8477A-01

S E R V I C E N O T E

8477A – Range Calibrator

8477A not able to power up under 115V

<u>Single Bobbin and Double Bobbin Transformer</u>:

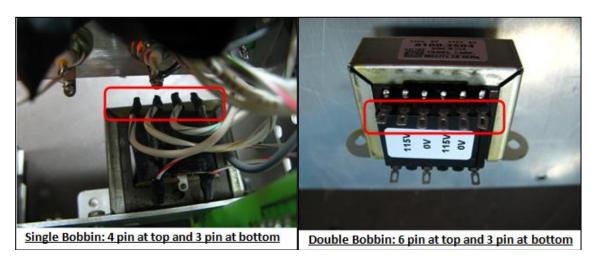
From Dec 2011, there is a change of 8477A transformer from single bobbin to double bobbin, unit within the serial number range stated above might not able to use under 115V due to the old method wiring on the transformer. There is no any safety impact to the instrument, and all units are able to work under 240V as normal unit. The only impact is the unit will not function under 115V.

If customer's unit is within serial number range stated above, please try to power up under 115V and 240V, if the unit is not able to power on under 115V and able to power on under 240V, then this service note applied. Please send the unit to nearest Agilent Service Center to rewire the unit.
